**DEVELOPMENT REVIEW BOARD MEETING
NOVEMBER 8, 2021
6:30 PM**

A. Resolution No. 396. Meridian United Church of Christ (Frog Pond Church): Ben Altman, Pacific Community Design Inc. – Representative for Meridian United Church of Christ – Owner/Applicant. The applicant is requesting approval of a Zone Map Amendment from Residential Agricultural-Holding (RA-H) to Planned Development Residential – 4 (PDR-4), and adopting findings and conditions approving a Stage I Master Plan, Stage II Final Plan, Tentative Partition Plat, and Setback Waiver for Meridian United Church of Christ (Frog Pond Church). The subject site is located at 6750 SW Boeckman Road on Tax Lot 5500, Section 13AA, Township 3 South, Range 1 West, Willamette Meridian, Clackamas County, Oregon. Staff: Cindy Luxhoj

**DEVELOPMENT REVIEW BOARD
RESOLUTION NO. 396**

Meridian United Church of Christ (Frog Pond Church)
Three-parcel Partition and Zone Map Amendment

Partition Phasing Plan

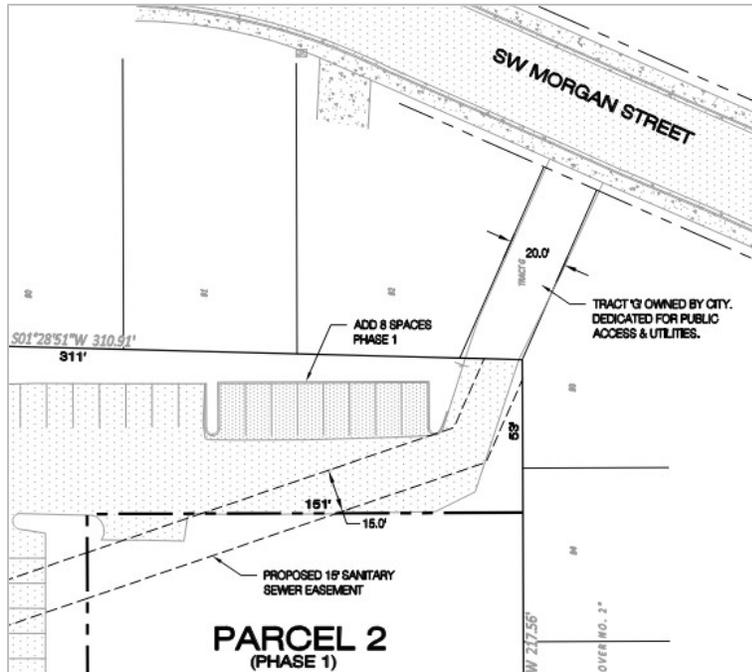
Since submittal of their materials for review, the applicant has continued to revise the configuration of the proposed partition. The most recent version of their proposal is shown below and included in the applicant's materials as Exhibit B3.

- Proposed Phase 1, anticipated to occur within two years of Development Review Board decision on the project:
 - Create Parcel 1, including 62,868 square feet (1.44 acres), containing the entire church building, landscaping, parking, and other site improvements
 - Create Parcel 2, including 17,480 square feet (0.40 acre) of developable area, on the south side of the property with a 35-foot-wide extension north along the existing drive aisle, containing 11,485 square feet (0.26 acre), to provide

access from SW Boeckman Road as well as required street frontage for the parcel

- Create Tract A, including 12,439 square feet (0.29 acre), containing the existing stormwater facility, landscaping and parking along the west property boundary

Subsection 4.118 (.03) A.

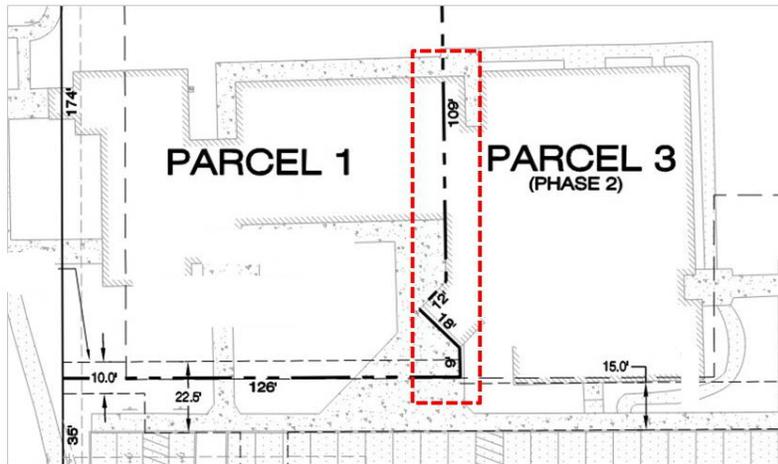
E1. Phase 2 of the partition proposes to divide Parcel 1, containing the church building and grounds, into two, Parcels 1 and 3, separating the newer sanctuary from the remainder of the building. The current application requests rezoning of the property from RA-H to PDR-4. Required minimum setbacks in the PDR-4 zone for lots exceeding 10,000 square feet in size are: 15 feet front; 5 feet side for one story and 7 feet side for two or more stories; and 15 feet rear for one story and 20 feet rear for two or more stories. The applicant is requesting a setback waiver to allow a zero lot line between the resulting buildings on Parcels 1 and 3, as highlighted in the illustration below, as it is not possible to meet the required setbacks.

Other than responding to this compliance requirement, which is necessary to accomplish the partition of the existing building on two parcels, the applicant’s narrative and code response has not provided any evidence that the setback waiver better implements the purposes and objectives of this Subsection.
